ATTACHMENT A: Project Modification Request (PMR) Form

Regional Program	<input checked="" type="checkbox"/> Infrastructure Program Project <input type="checkbox"/> Scientific Studies Program <input type="checkbox"/> Technical Resources Program
Project/Study Name	Edward Vincent Jr. Park Stormwater Improvements Project
Project/Study Lead	City of Inglewood
Watershed Area(s)	Central Santa Monica Bay
Current Project Phase	Design
Estimated Completion Date of Funded Activity	6/26/2026
Approved Stormwater Investment Plan Fiscal Year	FY24-25
Transfer Agreement ID (e.g., 2020RPULAR52)	2022RPCSMB02

Regional Program	<input checked="" type="checkbox"/> Infrastructure Program Project <input type="checkbox"/> Scientific Studies Program <input type="checkbox"/> Technical Resources Program
Project/Study Name	Washington Boulevard Stormwater and Urban Runoff Diversion
Project/Study Lead	City of Culver City
Watershed Area(s)	Central Santa Monica Bay
Current Project Phase	Design
Estimated Completion Date of Funded Activity	June 2027
Approved Stormwater Investment Plan Fiscal Year	2020-21
Transfer Agreement ID (e.g., 2020RPULAR52)	2020RPCSMB07

Figure 1-1 General Project Concept

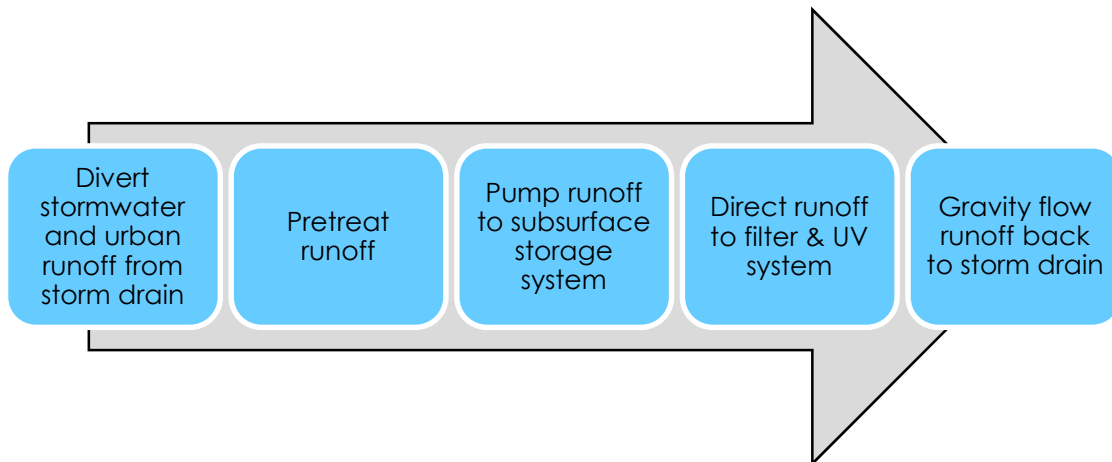
Bid documents and specifications were posted online and a pre-bid meeting was held in June 2023. Once bids were received, the bids exceeded the budget for the previous design approach. The City sought alternative designs to reduce the construction cost. The original design proposed a subsurface storage system beneath Washington Boulevard. The captured stormwater runoff will be released from the tank and pumped to the sanitary sewer. The proposed modification is installing the subsurface storage system beneath the sidewalk on Glencoe Avenue where direct runoff will be filtered and treated by an Ultra-Violet (UV) system. The treated stormwater runoff will be routed back to the storm drain via gravity flow. The improvements are demonstrated in Figure 2 in the attachment, and are outlined below:

Figure 2-1 Design Approach

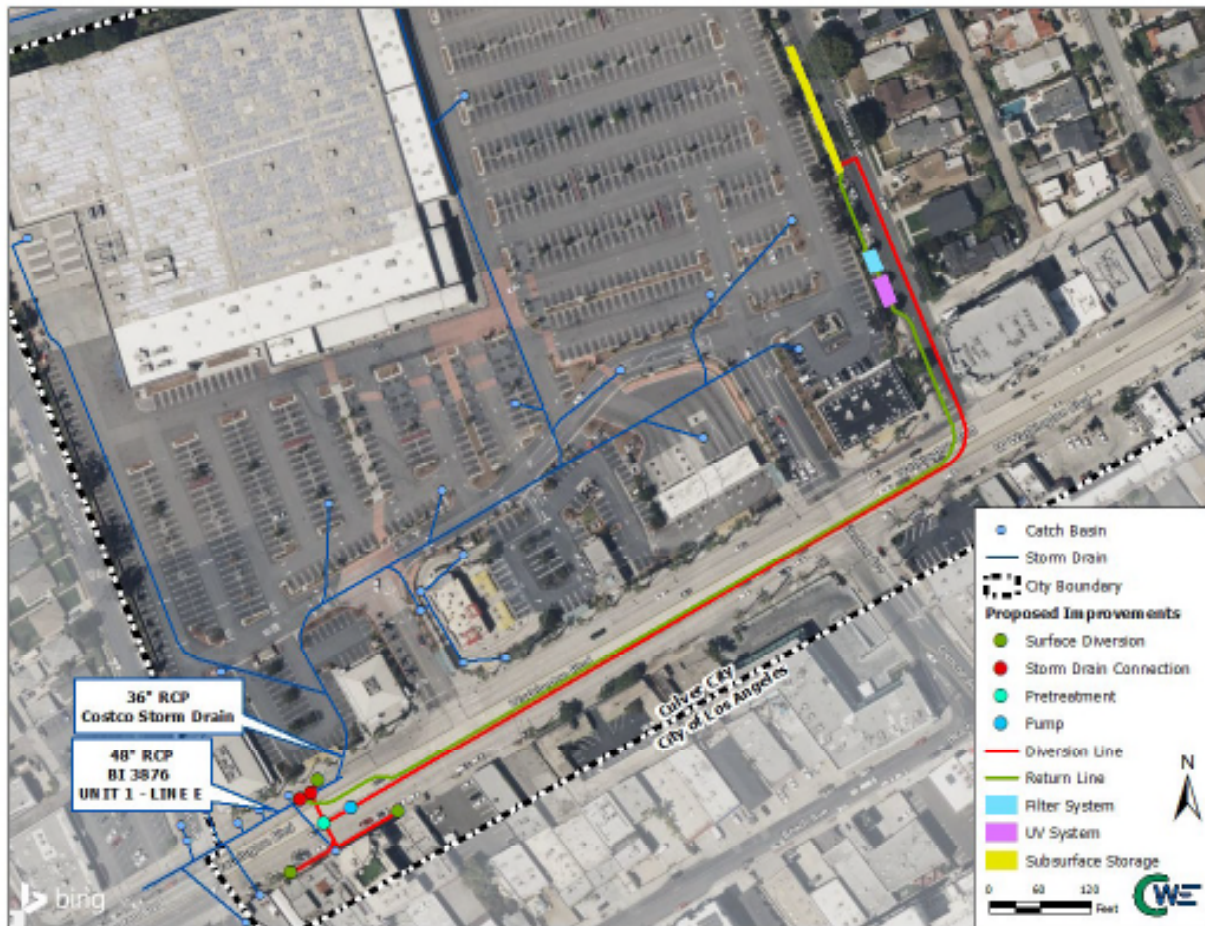
Three surface diversion points are proposed to capture the 85th percentile, 24-hour storm event peak runoff that is tributary to each element.

Flows will be pumped to the subsurface storage system at Glencoe Avenue, where some will be retained for irrigation and some to move downstream for further treatment.

The filter system will treat the flows discharged by gravity from the subsurface storage system that are not used for irrigation.

A UV system composed of two units will provide additional treatment for bacteria and pathogens after the filter system. The smaller UV unit will be used for dry-weather flows. Both units will be used for wet-weather flows.
